CABINET PRIORITISATION SUB COMMITTEE

Report Title:	Brocket Task and Finish Group
Contains Confidential or Exempt Information?	NO - Part I
Member reporting:	Councillor Gerry Clark, Chair of Task and Finish Group
Meeting and Date:	Cabinet Prioritisation Sub Committee 17 May 2017
Responsible Officer(s):	
Wards affected:	Boyn Hill

THE BROCKET . BOYN HILL AVENUE . MAIDENHEAD
FEASIBILITY STUDY

Comment by Cllr Claire Stretton on the Feasibility Study conducted by CSK Architects to ascertain its suitability for use as a residential scheme or mixed-use scheme with the Registrar's Office

MIXED USE SCHEME -
REGISTRY OFFICE + RESIDENTIAL

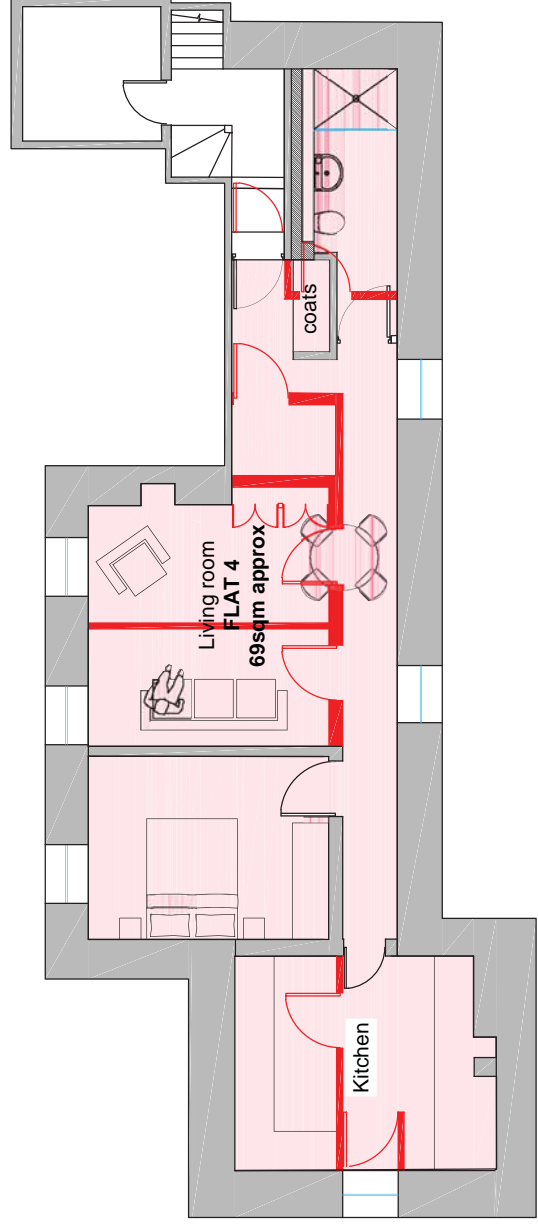
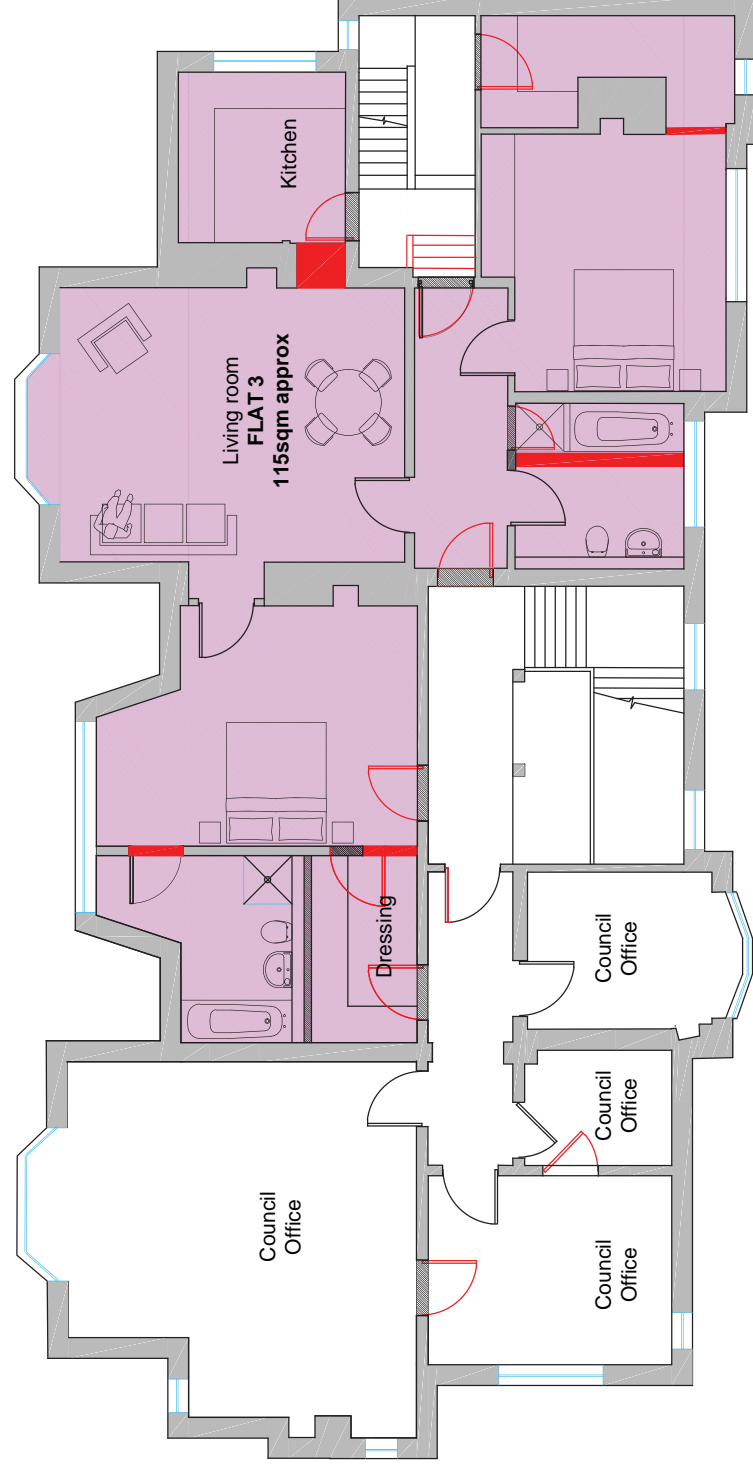
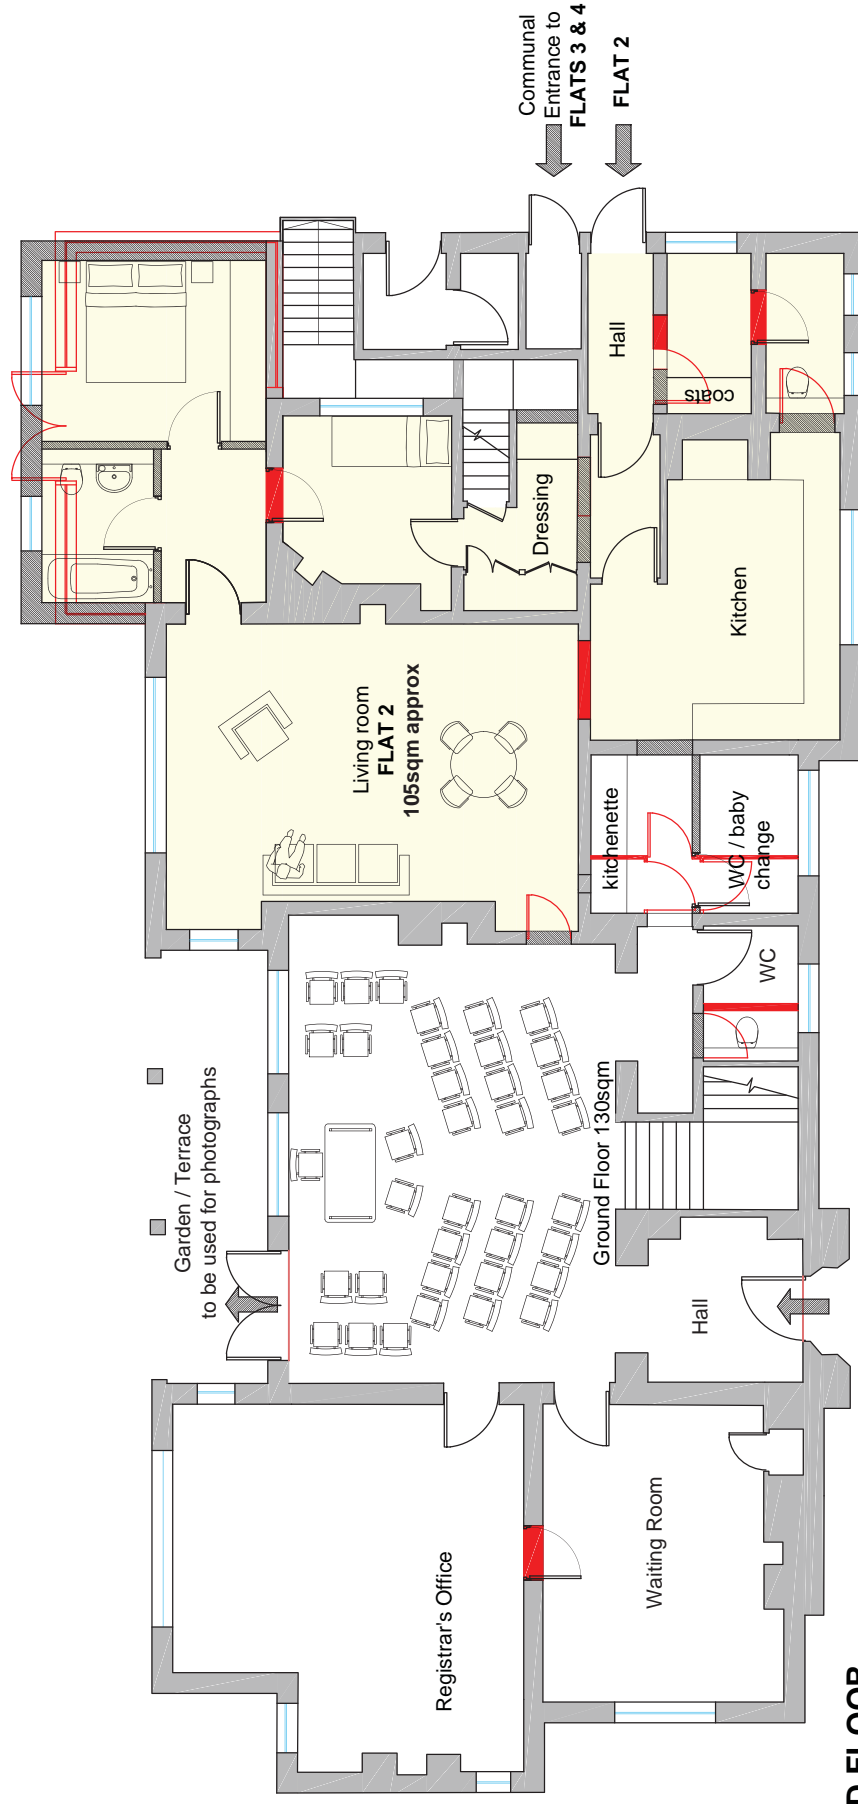
Disadvantages: The main room isn't that big – it can't accommodate the 48 visitors usually needed for a large marriage. Because it is a listed building it is not a simple case of knocking two rooms together to create a larger room. The integrity of each of the main rooms with their associated cornice/panelling/skirting etc must be respected.

There is limited options to increase the parking on the site, beyond 12 spaces. Depending on the status of the Copper Beech on site, even this number of spaces may not be possible. For a large marriage with say 30 guests, parking will not be sufficient.

There is both a vertical and horizontal overlap between commercial space and residential accommodation with complicates both the acoustic and the fire separation.

It is difficult to see how marriages could be run back to back. Access to the main waiting area involves entering the main room where the service would be in progress.

A - *"It is difficult to see how marriages could be run back to back. Access to the main waiting area involves entering the main room where the service would be in progress."* This is only true because of where CSK Architects have chosen to put the Waiting Room. See Works Required and Plans.

MIXED USE SCHEME -
 REGISTRY OFFICE + RESIDENTIAL

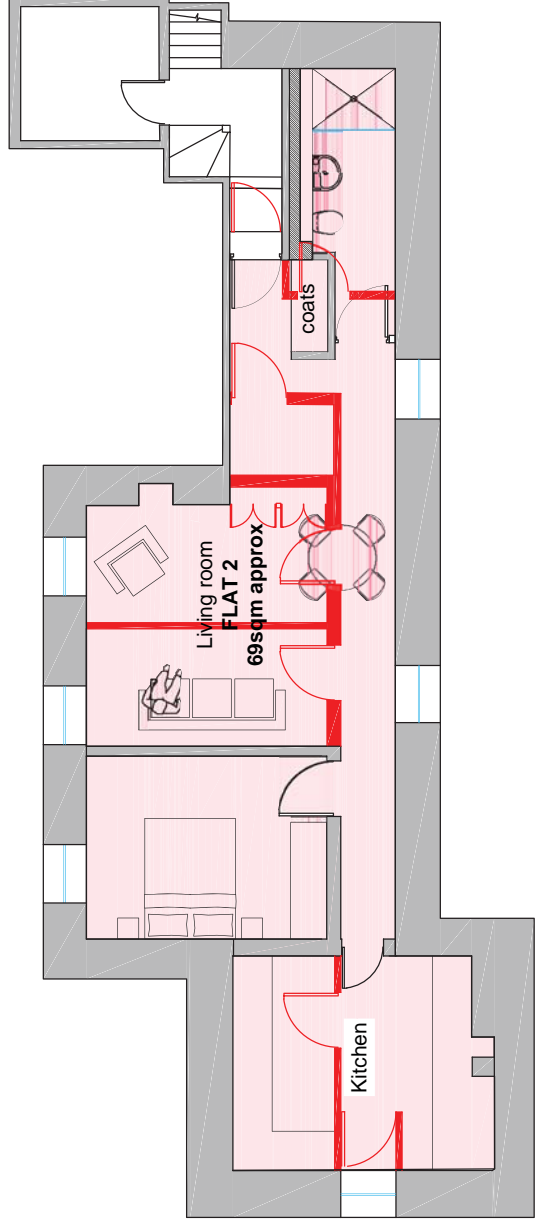
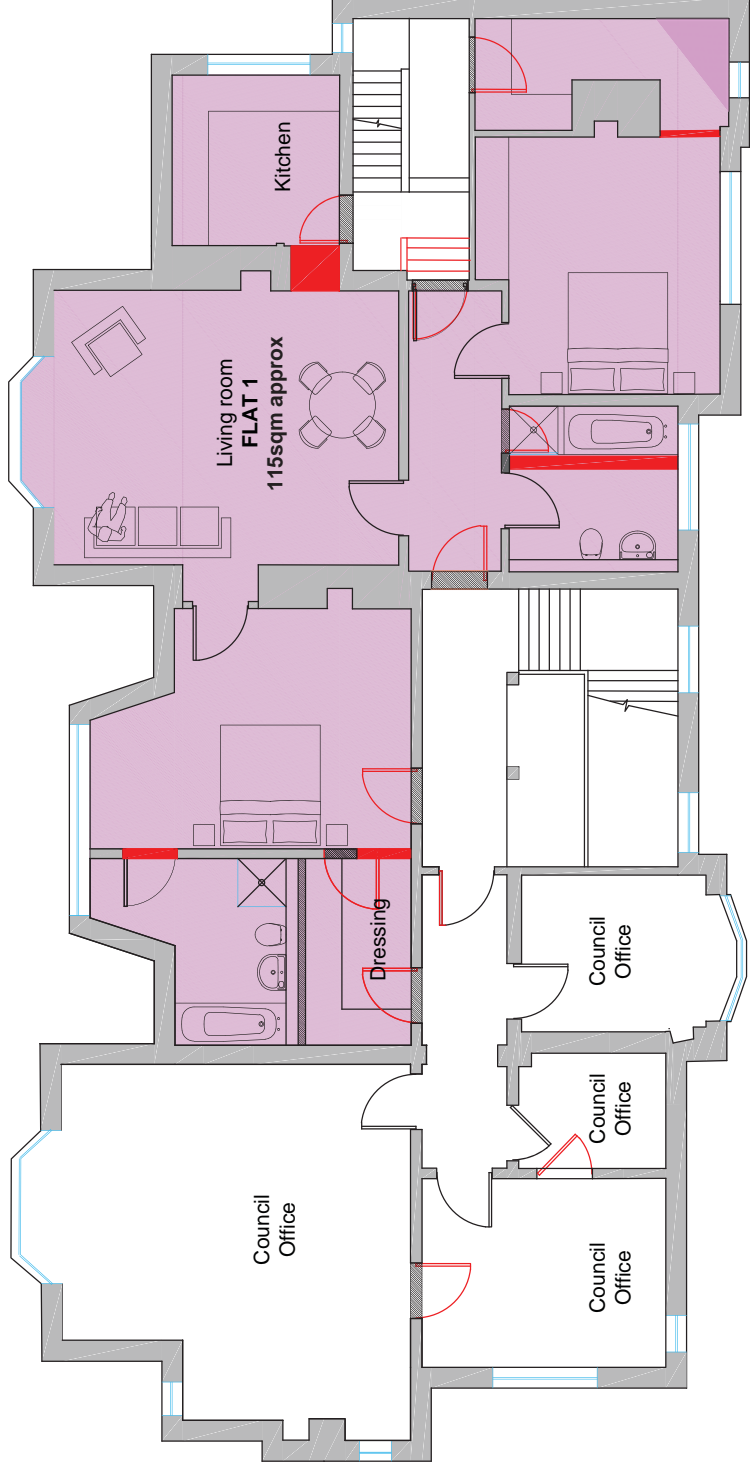
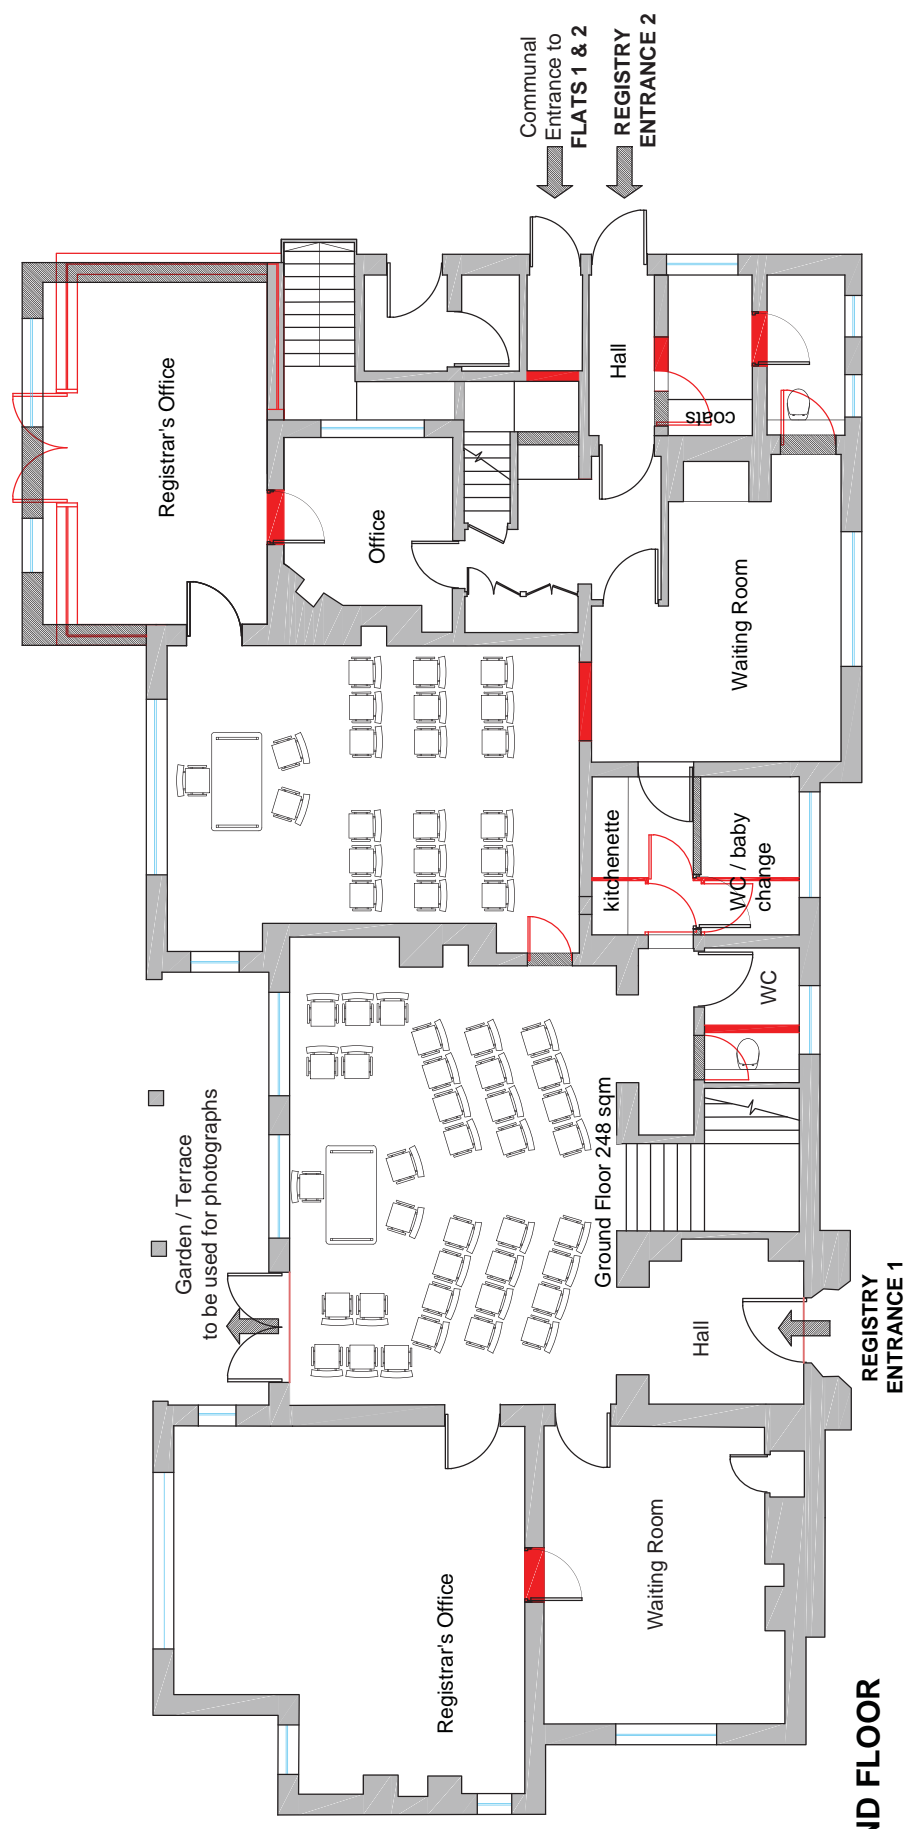
Disadvantages: The main room isn't that big – it can't accommodate the 48 visitors usually needed for a large marriage. Because it is a listed building it is not a simple case of knocking two rooms together to create a larger room. The integrity of each of the main rooms with their associated cornice/panelling/skirting etc must be respected.

There is limited options to increase the parking on the site, beyond 12 spaces. Depending on the status of the Copper Beech on site, even this number of spaces may not be possible. If two wedding services were being conducted simultaneously, as the plan suggests, parking problems will be even more problematic than option 3.

The existing principal stair must be retained and it must lead somewhere. This necessitates commercial space at first floor.

There is a vertical overlap between commercial space and residential accommodation which complicates acoustic / fire separation.

B - *"The existing principal stair must be retained and it must lead somewhere. This necessitates commercial space at first floor."* I agree and this is not a disadvantage. See Works Required and Plans.

BROCKET MAIDENHEAD	1:125 @ A3	08/2016
REGISTRY OFFICE, MEETING ROOMS AND CARETAKER FLAT

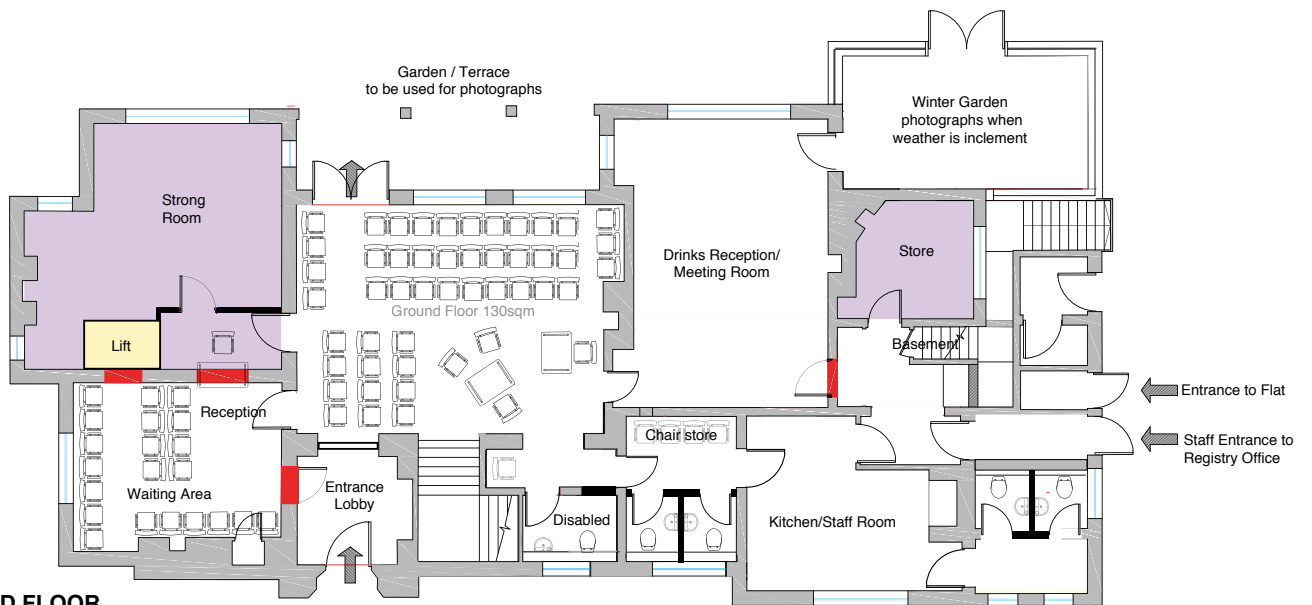
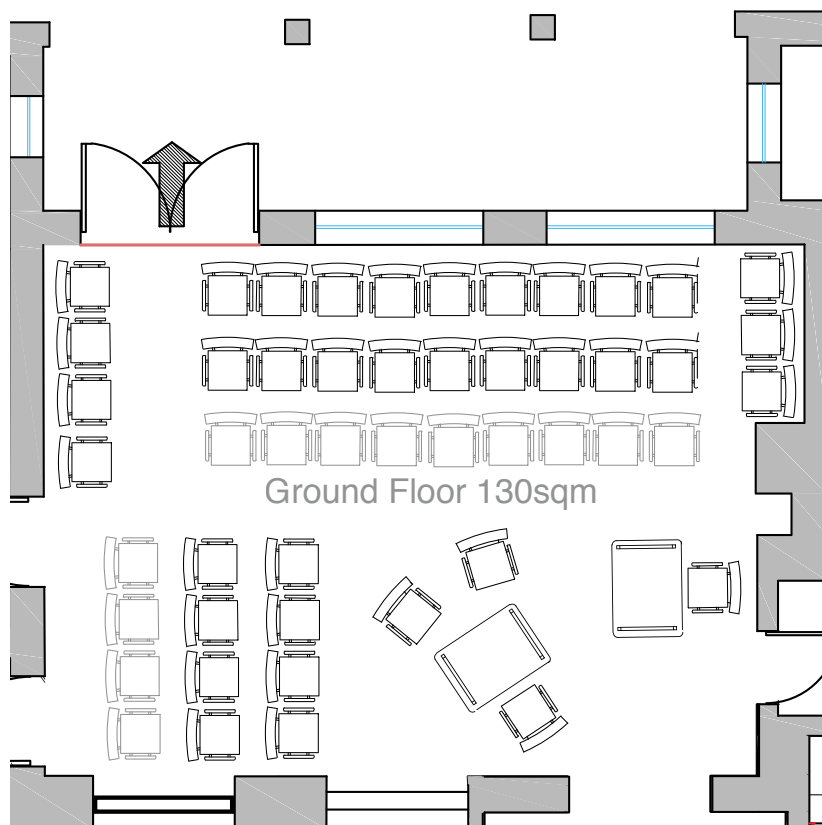
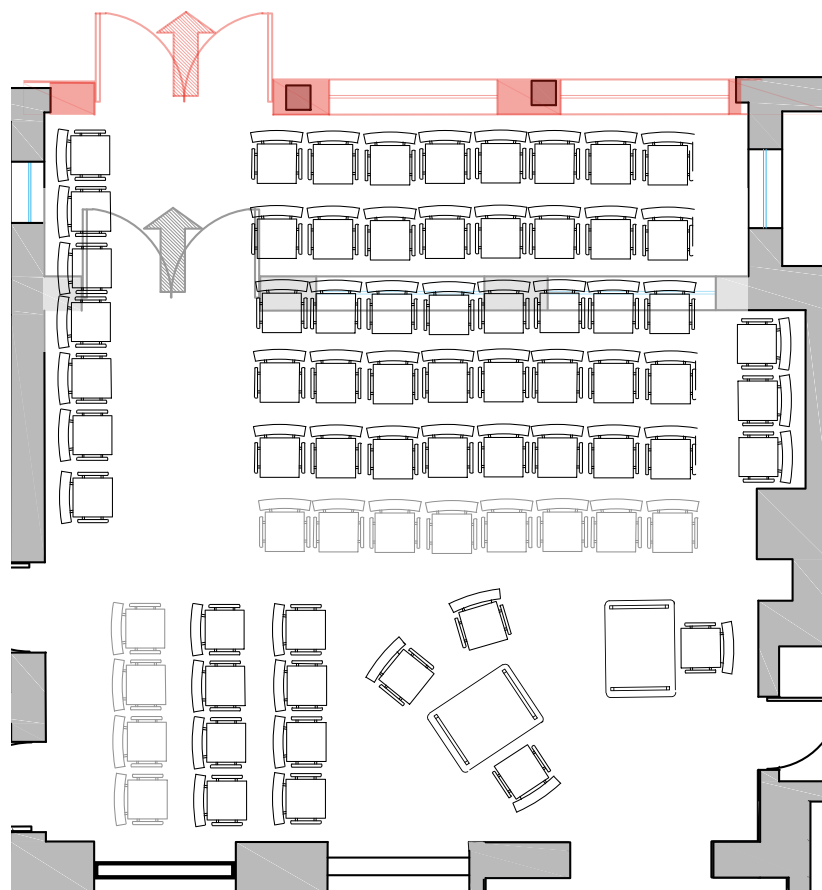
I note the Feasibility Study conducted by CSK Architects and, I am disappointed that each of the plans requires the demolition of the original "Winter Garden" and considerable reconfiguration of the internal rooms, both of which are specifically mentioned in the Grade II Listing text. I understand that this Feasibility Study was also to ascertain whether the building could provide for "Key Worker Housing". I also note the conclusion drawn, which is: *"Due to parking restrictions and the layout of the listed building, in particular the principal reception room and principal stair, we consider this building is best suited to a wholly residential conversion as opposed to a mixed use scheme"*.

- 1 A new doorway from the Entrance Hall to the Reception and Waiting Area and installation of glass screen or door between the Entrance Hall and the Ceremony Room

- 2 Secure shutter between Reception and receptionists office with wall added to provide a Strong Room behind.
- 3 A small passenger lift to enable disabled access to the first floor, access from the Waiting Area.

- 4 Suitable toilets installed, including for the disabled on both ground and first floors.
- 5 Conversion of the roof space into a one-bedroom Caretakers Flat with suitable fire and acoustic separation in the floor.

- 6 Landscape the Gardens to improve the setting of the Listed building and provide for Photographs.
- 7 (Optional see page 4) Extending the Ceremony Room by moving one wall out to meet the existing roof.

I have demonstrated in the attached plans on page 3, that by utilising a more pragmatic layout, how 48 guests (including the bride and bridegroom) can be

By turning the orientation around from the architects suggested layout, this area could comfortably seat 35 Guests with Bride and Groom, with a maximum of 48, by adding the rows shown in grey. Seating in a Church or similar is unlikely to provide much more leg room than this. The signing of the Register takes place inside this room, as now.

If the Conservation Officer felt that, to enable more public use of this building, it could be appropriate to extend by relocating the current wall and windows to where the pillars currently stand which support the overhanging roof, then this area could comfortably seat 60 Guests with Bride and Groom, with a maximum of 72, by adding the rows shown in grey.

The main hall itself is quite fine in its detailing and scale and it is unlikely to be able to be extended into the external verandah area as it will change the proportion of the room. If wedding ceremonies are proposed then they will need to be arranged within the confines of the existing space available. Shown at face value, this looks as quite tight in terms of access and chair proximity. A mock layout has been set up in-situ to establish exactly how many chair spaces can realistically be accommodated in the space – please see attached photos. This indicates that the main hall can only facilitate a maximum of 32 people. This is significantly lower than the required 50 that has been advised by the current Registrar.

To conclude, we still consider the proposed interventions to facilitate a registry office within the listed building would not be acceptable in terms of Conservation policies. The building was originally designed as a dwelling and as such the rooms are, whilst larger than average for a house, domestic in their scale and not suitable for use as a public building. The Registry office requires a large ceremony room which the Brocket is unable to provide. Alternative public uses will have the same issues of having to adapt the building to be fully accessible, with the intervention of ramp / lift etc. The issue of additional parking requirements will also apply leading to further on-street parking or the destruction of the rear garden, loss of part of the listed garden wall and removal of important tree screening. All of which would no doubt be of concern to the local residents and also be detrimental to the fabric and setting of the building.
